UNITED STATES PATENT AND TRADEMARK OFFICE

| APPLICATION NO. | FILING DATE | FIRST NAMED INVENTOR | ATTORNEY DOCKET NO. | CONFIRMATION NO. |
|-----------------|-------------|----------------------|---------------------|------------------|
| 09/516,753 | 03/01/2000 | Gregory Pinchasik | 2390/49701 | 3706 |

Office Action Summary

DETAILED ACTION

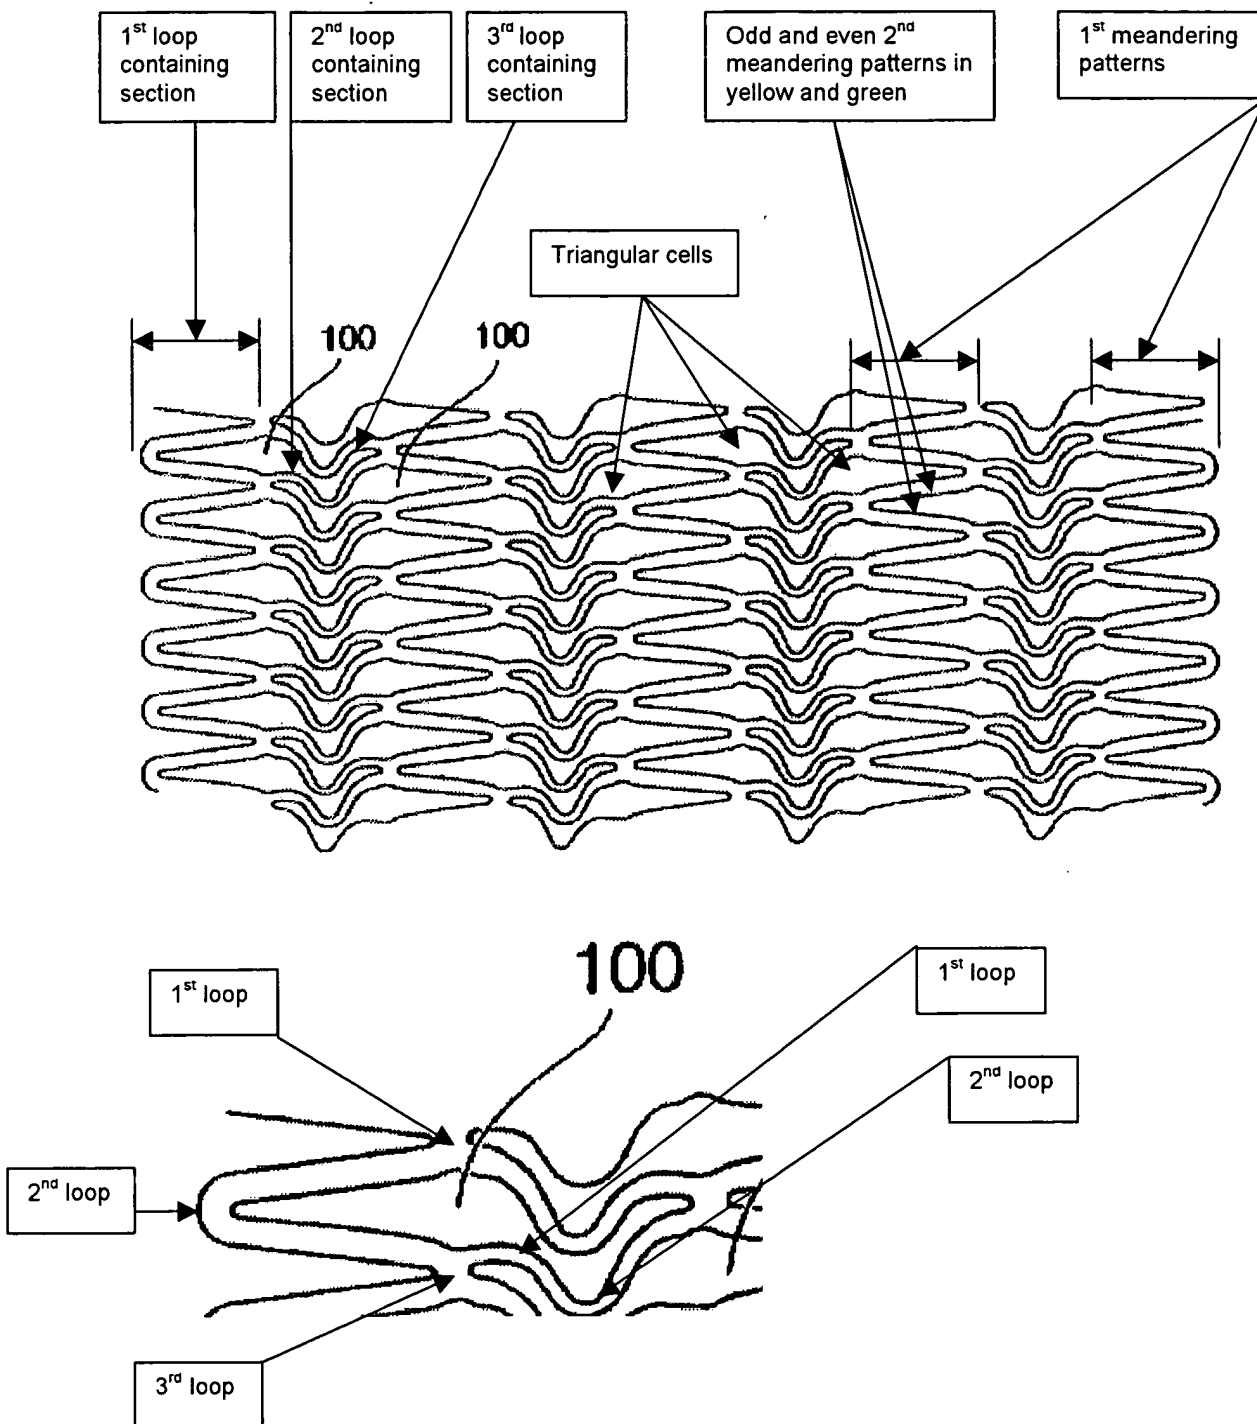
1. Claims 1-6, 9-11, 21, 23-25, 28-33, 35 are rejected under 35 U.S.C. 102(b) as being anticipated by Von Oepen-WO 98/35634.

Von Oepen-'634 (Fig. 10 as presented on page 3) discloses substantially all limitations as recited in the claims.

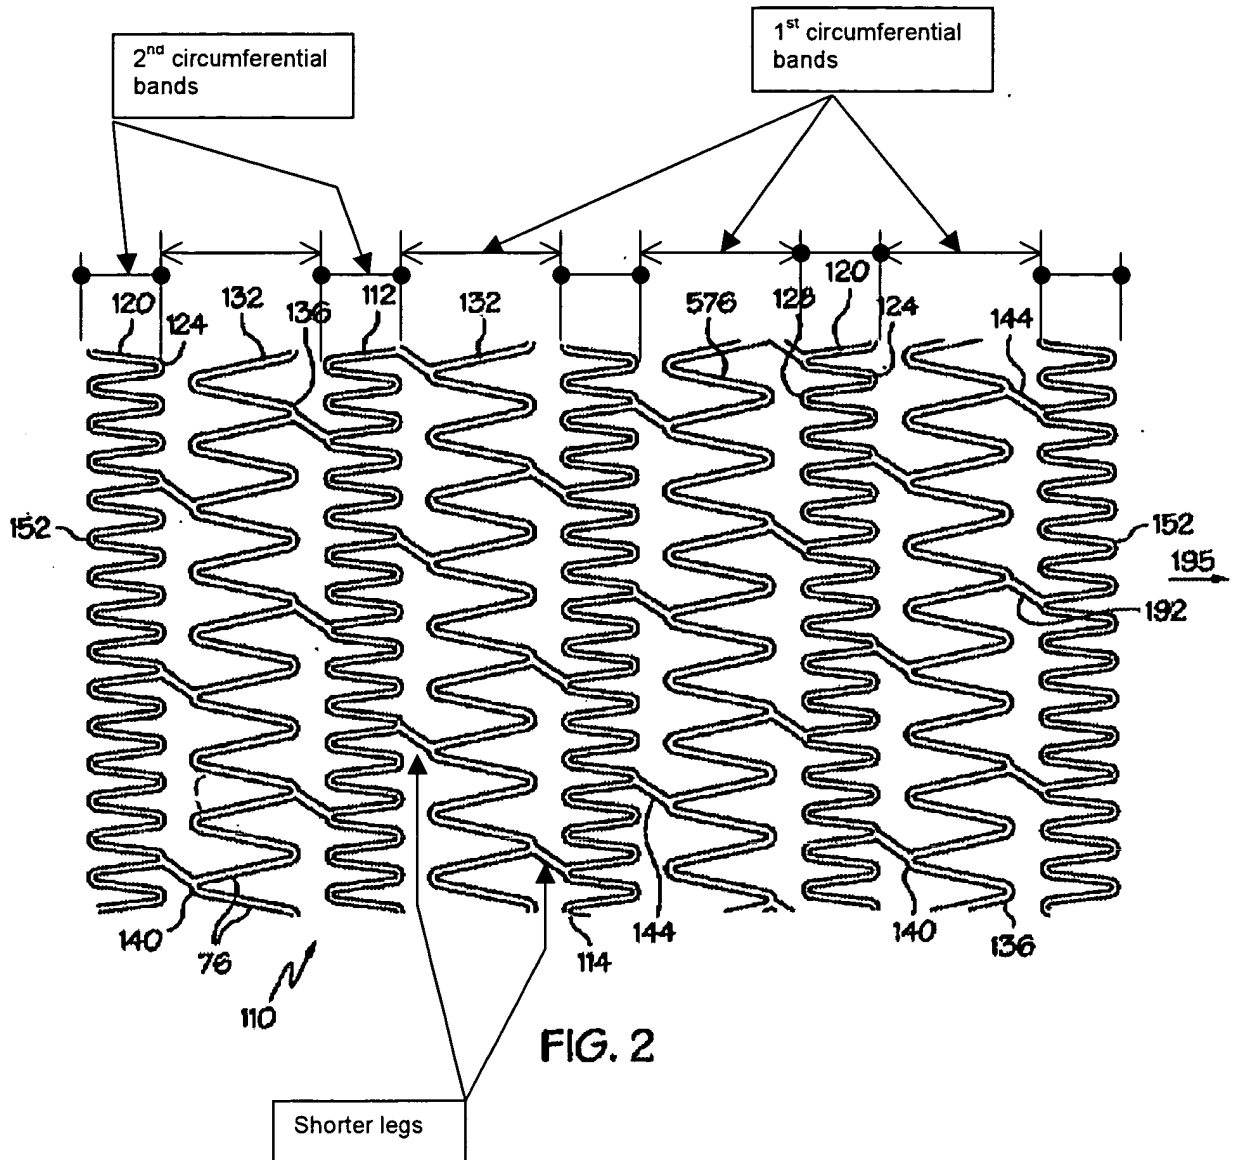
2. Claims 95-100, 104-105, 108-111, 113-114, 116-119, 122, 125 are rejected under 35 U.S.C. 103(a) as being unpatentable over Brown et al-6,776,793 in view of Von Oepen-WO 98/35634.

As to claims 95-102, 104-105, 108-111, 113-114, 116-119, 122 and 125, Brown-'793 (Fig. 2, reproduced and shown on next page) discloses substantially all limitations as recited in the claims, except for the 1st loop containing section has wider legs than the 2nd and 3rd loop containing sections.

However, it is well known in the art to have a stent with bands having wider legs alternating with bands having narrow legs to provide flexibility for the stent. For example, Von Oepen (Fig. 10) above shows bands of 1st loop containing section having wider legs and bands of 2nd and 3rd loop containing sections having narrower legs to enhance flexibility of the stent. In view of Von Oepen, it would have been obvious to one of ordinary skill in the art at the time of the invention to make bands of 1st loop containing sections of Brown stent to have legs wider than legs of bands formed of 2nd and 3rd loop containing sections so that Brown stent would be more flexible to adapt itself to a blood vessel. Notice that Brown's Fig. 2 shows 1st circumferential bands having a basically sinusoidal pattern of loops at a 1st frequency and 2nd circumferential bands having a basically sinusoidal pattern of loops at a 2nd frequency higher than the 1st frequency as recited in the claims.
